The 55 details drawn differently in CAD and Revit

Checked against the new drafters' file, 26 October.

55 of the 190 CAD typical details have a Revit version in your templates that is drawn differently. Each page: your CAD detail on the left, the Revit version on the right, what differs, and one answer: CAD is right, Revit is newer (we update CAD from it), or both wrong.

CAD: KOR-D302-DET 03 - BASEMENT WALL SECTION

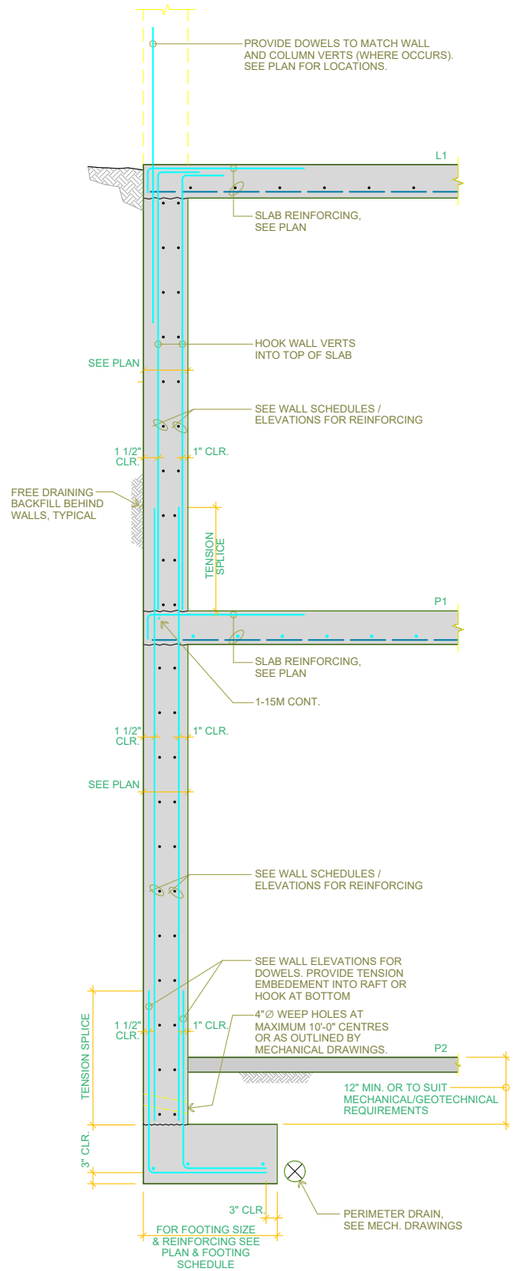
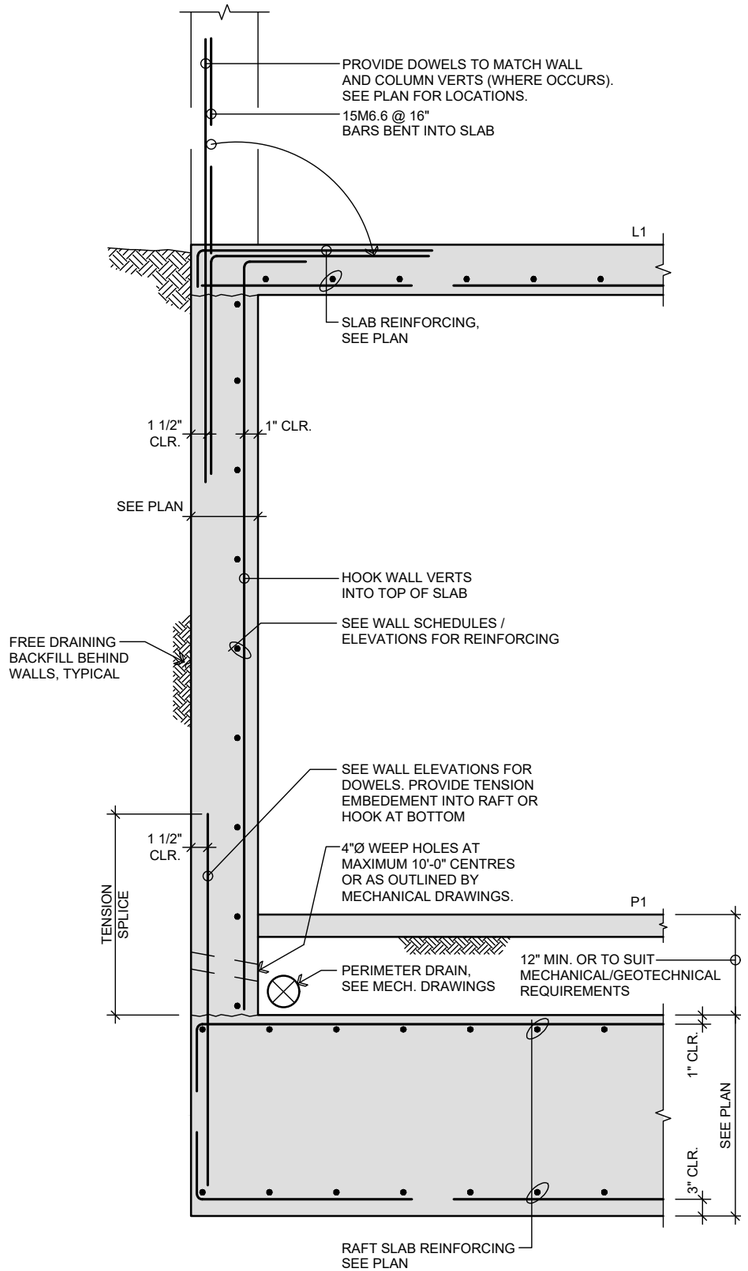
What differs: Single-storey basement wall on raft; 'D3.01_1_BASEMENT WALL SECTION' is three levels on strip footing.

CAD: KOR-D302-DET 04 - BASEMENT WALL SECTION

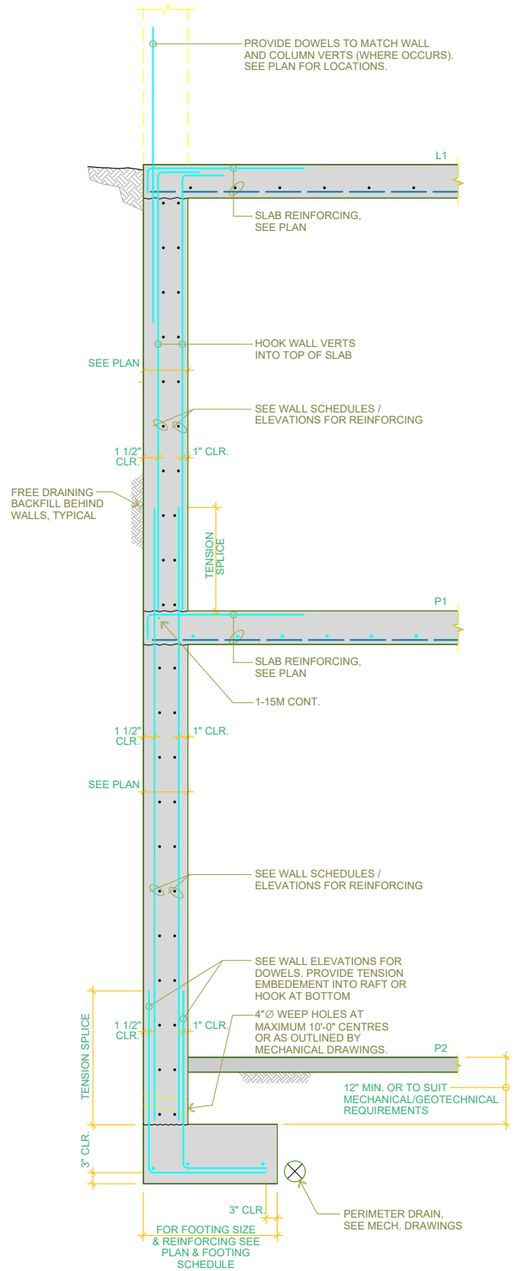
What differs: Single-storey basement wall on raft with slab dowel callout; 'D3.01_1_BASEMENT WALL SECTION' is three levels on strip footing.

CAD: KOR-D302-DET 05 - BASEMENT WALL SECTION

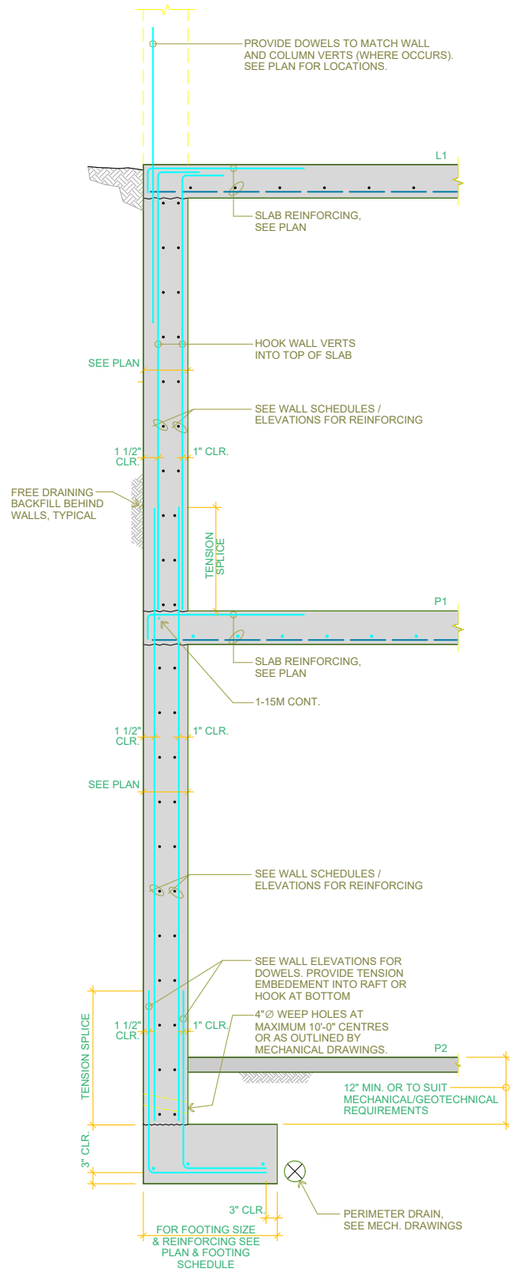
What differs: Tall multi-storey wall on raft; 'D3.01_1_BASEMENT WALL SECTION' is three levels on strip footing.

CAD: KOR-D302-DET 06 - BASEMENT WALL SECTION

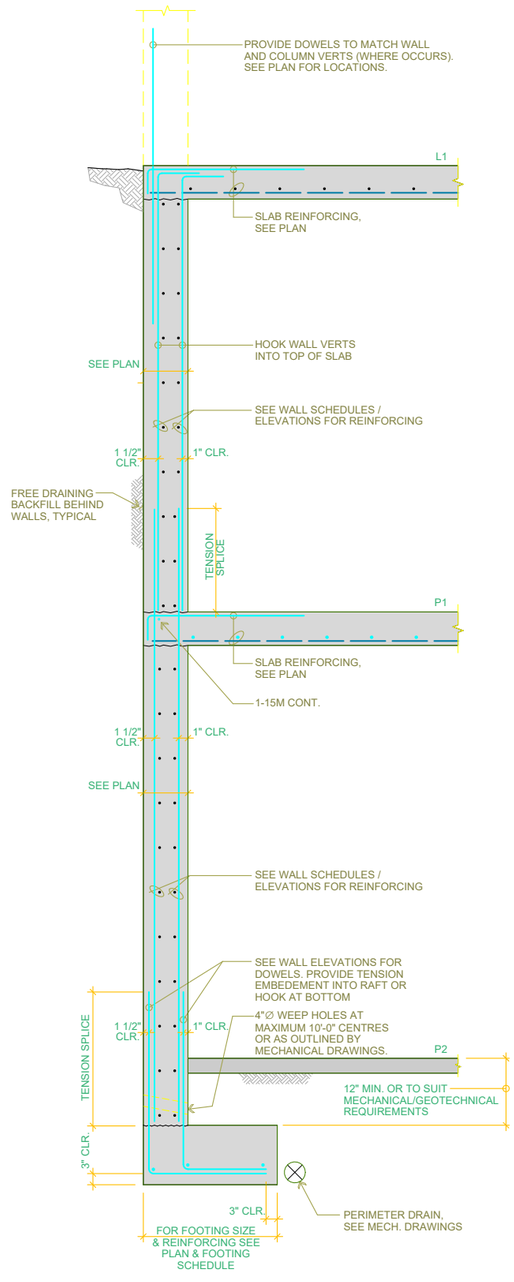
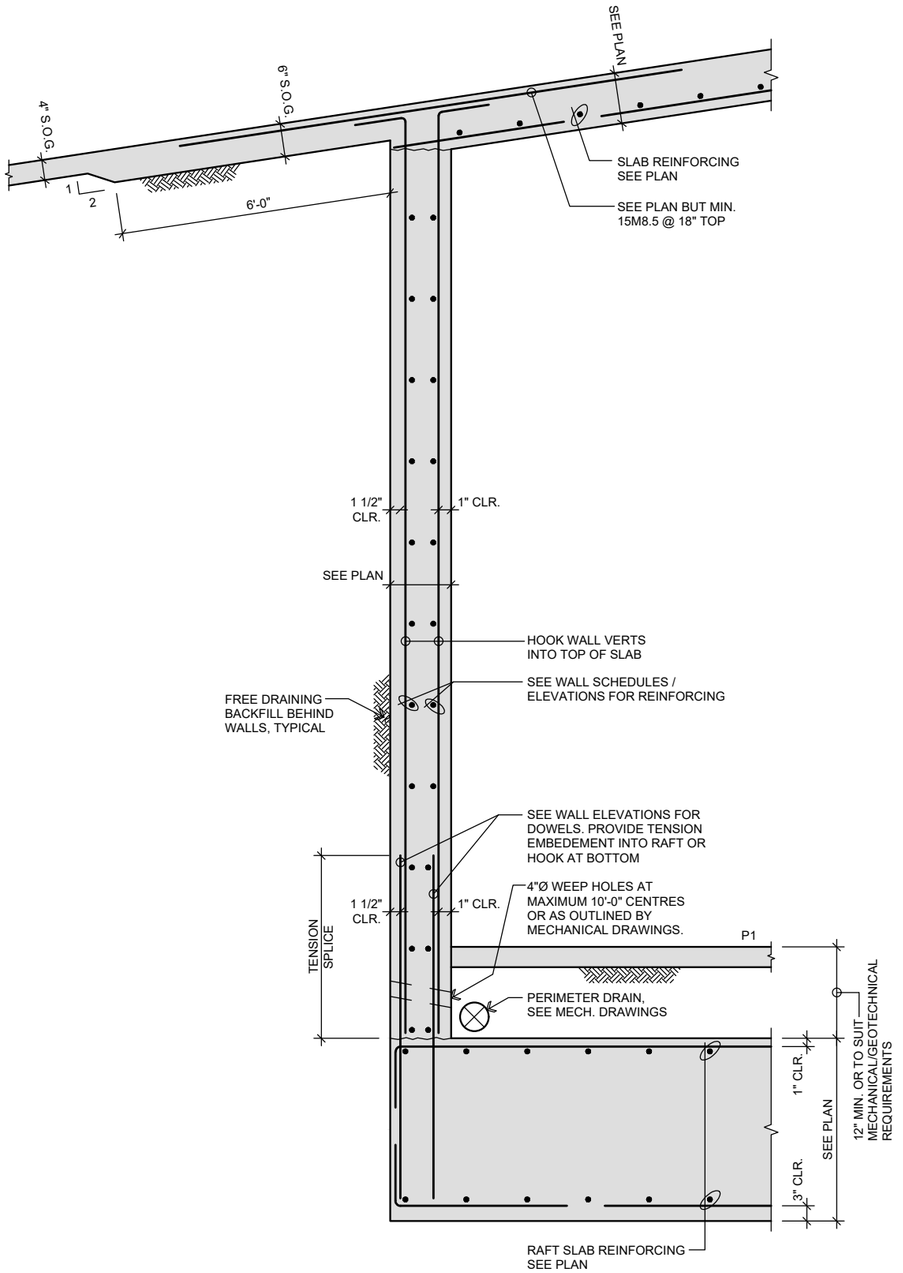
What differs: Tall multi-storey wall on raft; 'D3.01_1_BASEMENT WALL SECTION' is three levels on strip footing.

CAD: KOR-D302-DET 07 - BASEMENT WALL SECTION

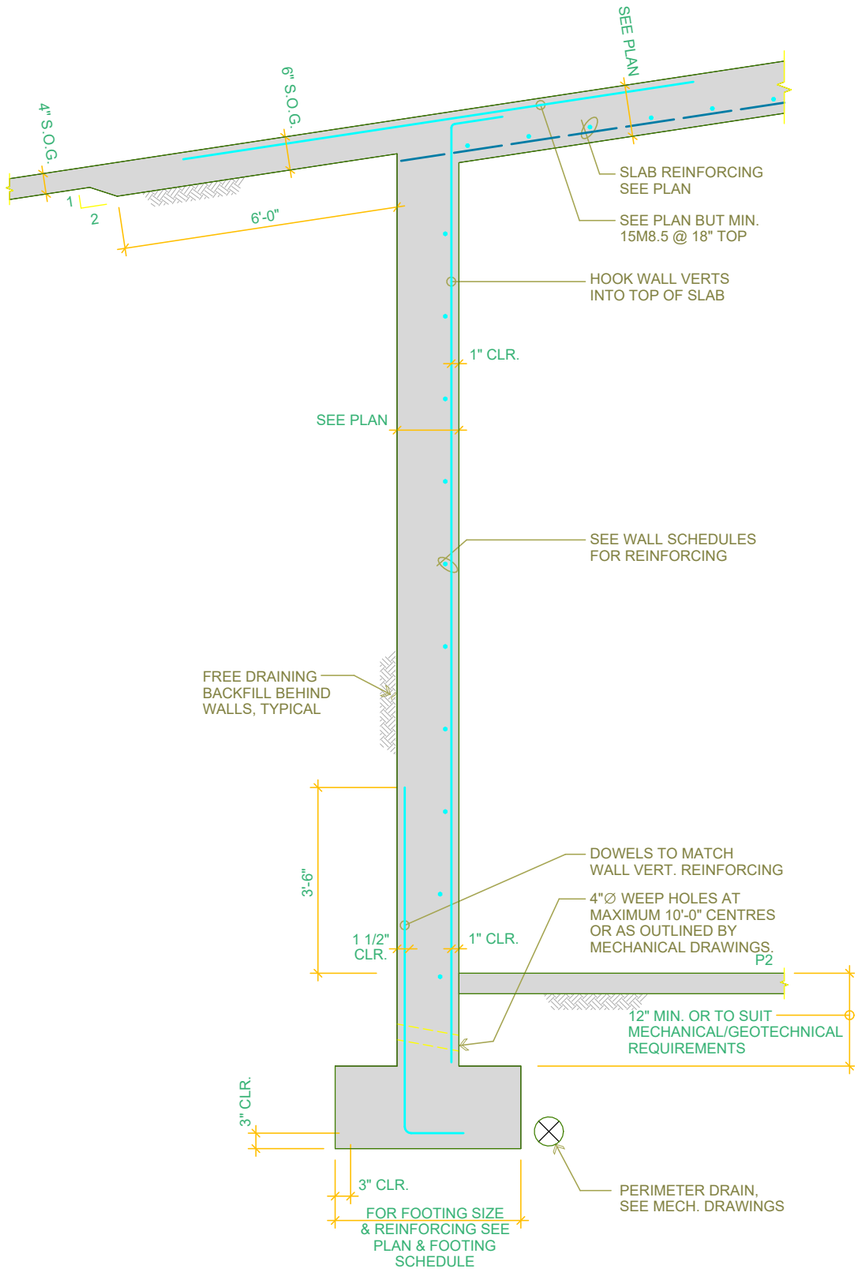
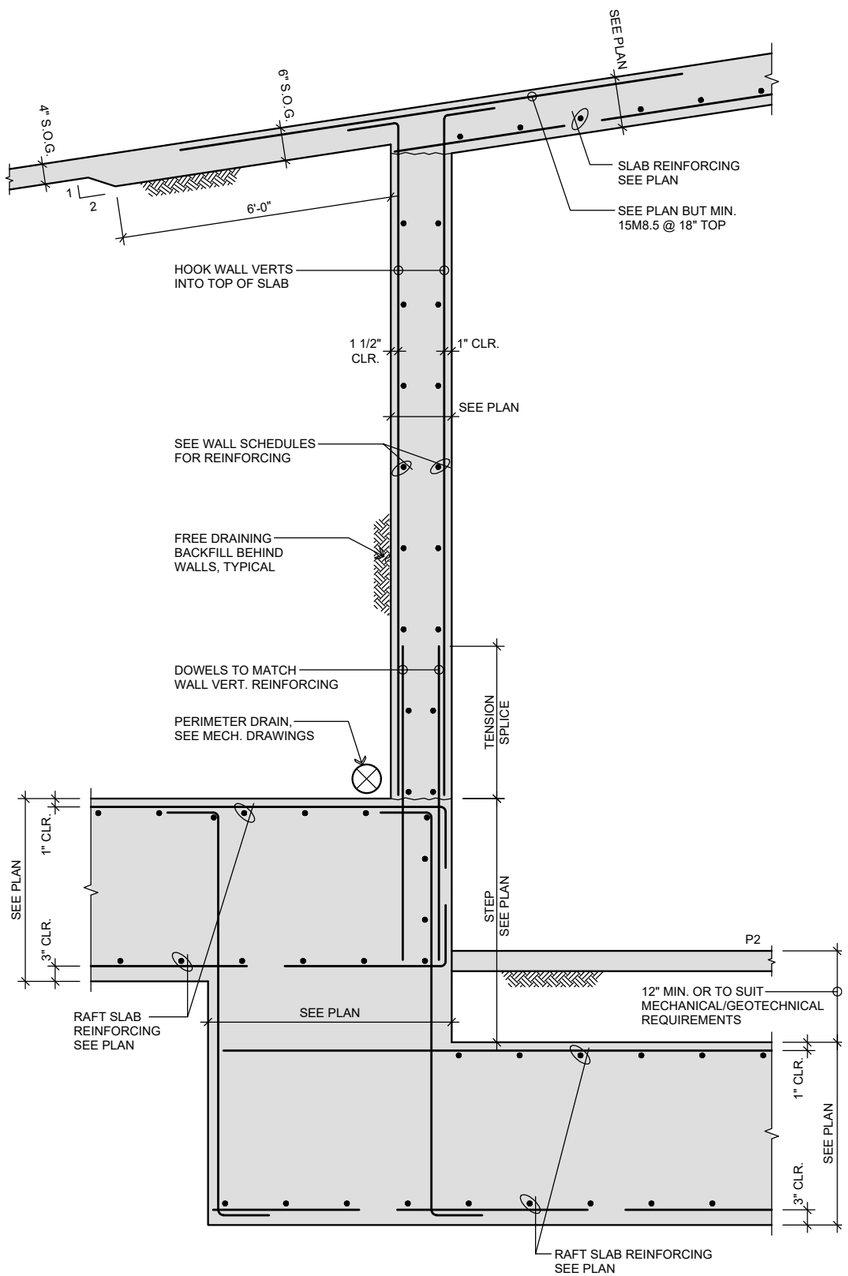
What differs: Wall with sloped slab over as 'S5.05_1_BASEMENT WALL DETAIL' but bearing on a raft rather than a strip footing.

CAD: KOR-D302-DET 08 - BASEMENT WALL SECTION

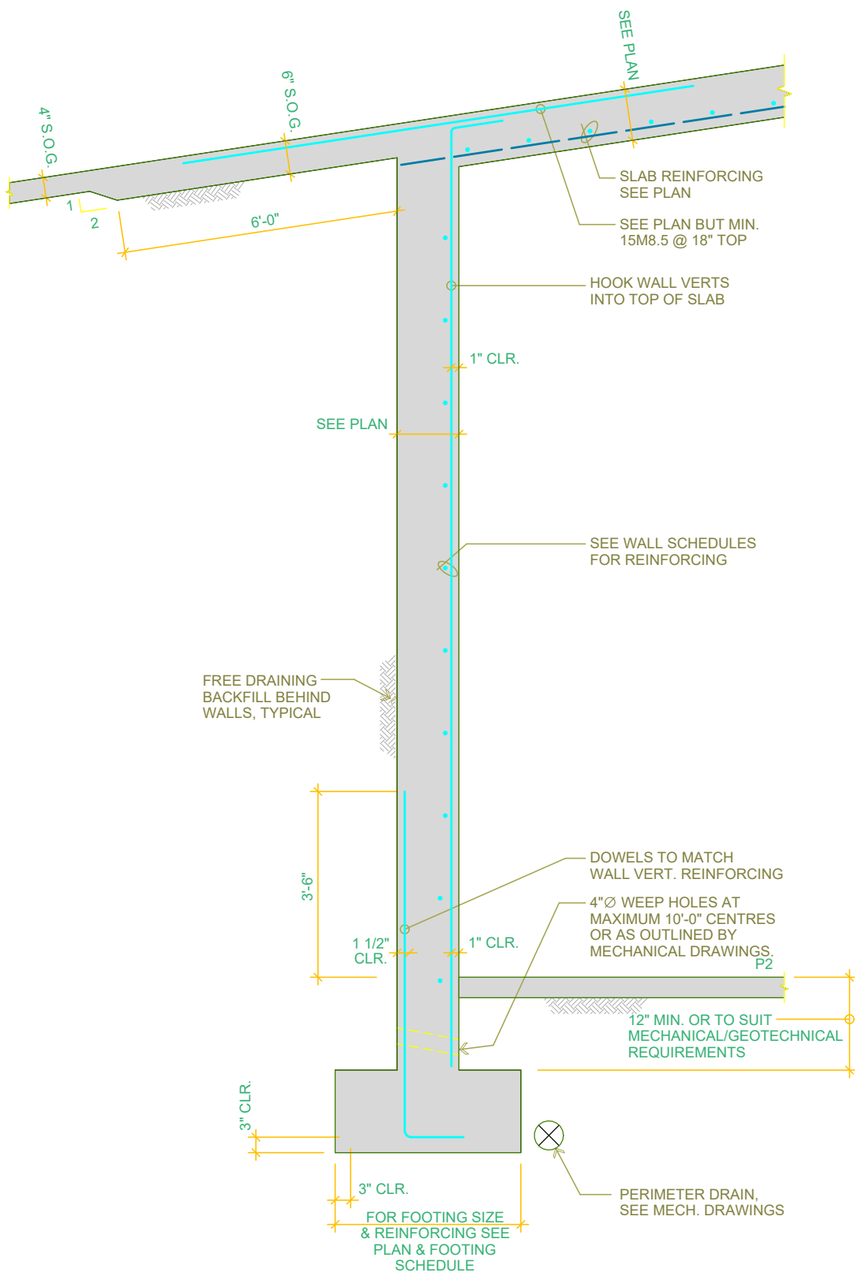
What differs: Wall with sloped slab over as 'S5.05_1_BASEMENT WALL DETAIL' but ending in a stepped raft rather than a strip footing.

CAD: KOR-D401-DET 04 - STEP SECTION

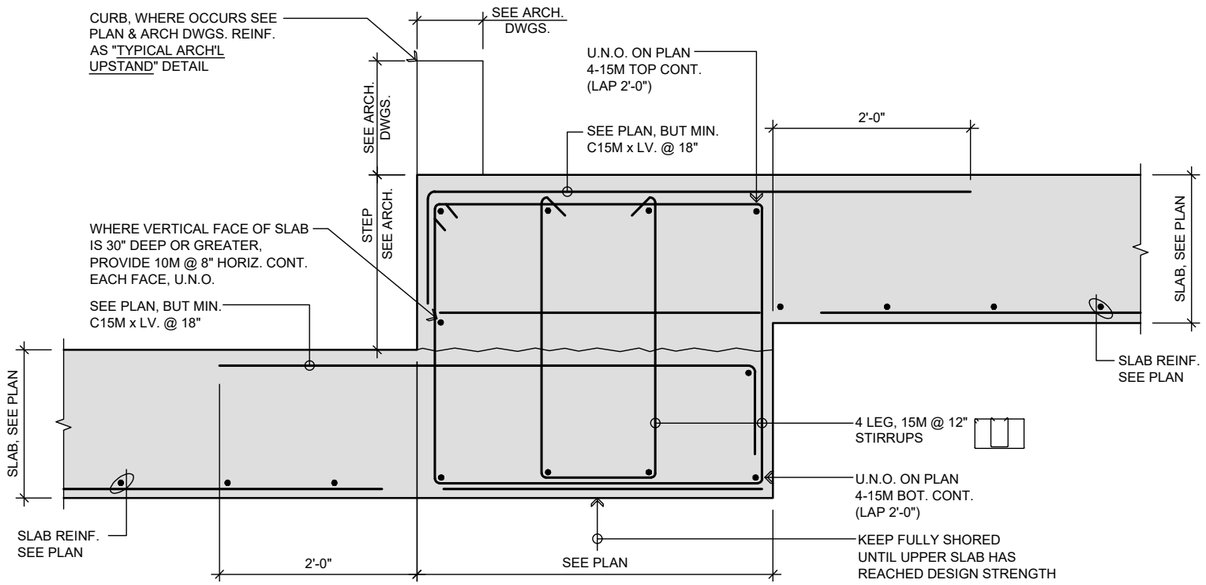
What differs: Top step built as a second pour with 10M grid dowel plus soffit step; 'D4.01_1_STEP SECTION' is a stirruped slab band step - closest only by purpose.

Revit: D5.01_4_RAMP DETAIL (Typical Details - Container_R23 (Need_MET & IMP).rvt; on D5.01 Series 5 Miscellan)

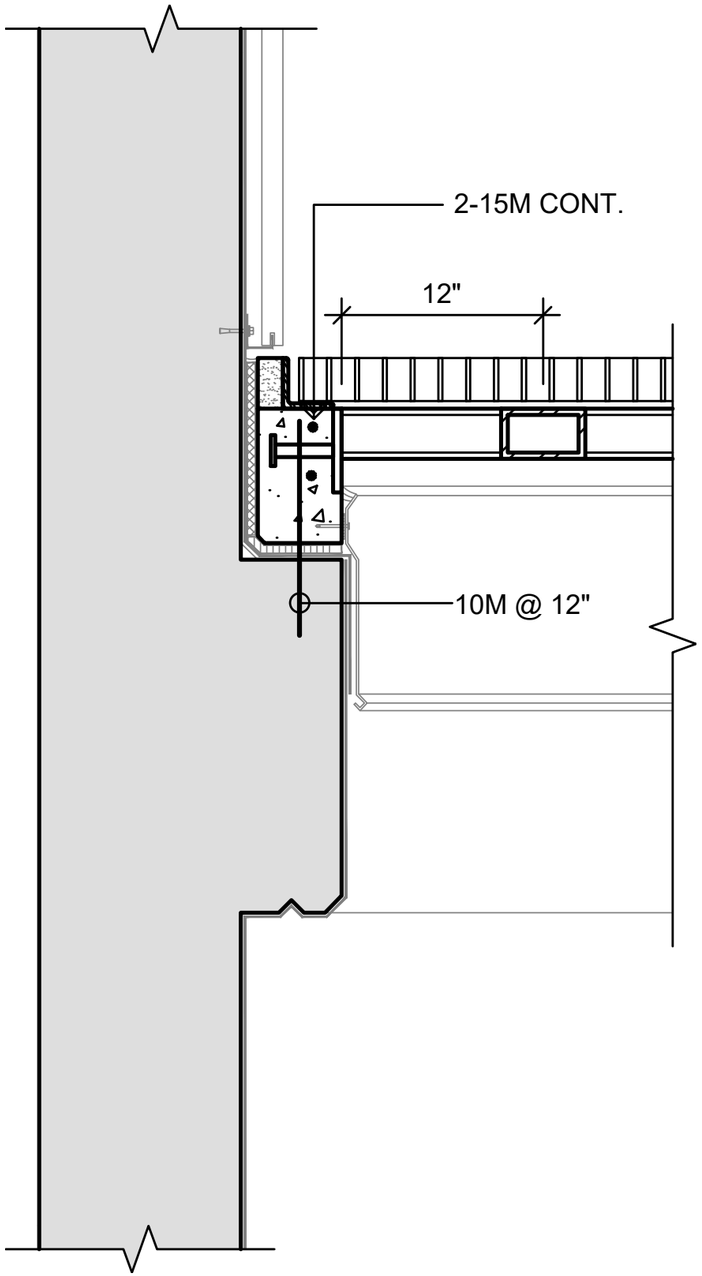
What differs: Ramp rising into slab band without 'D5.01_4_RAMP DETAIL"s cranked second set of top bars.
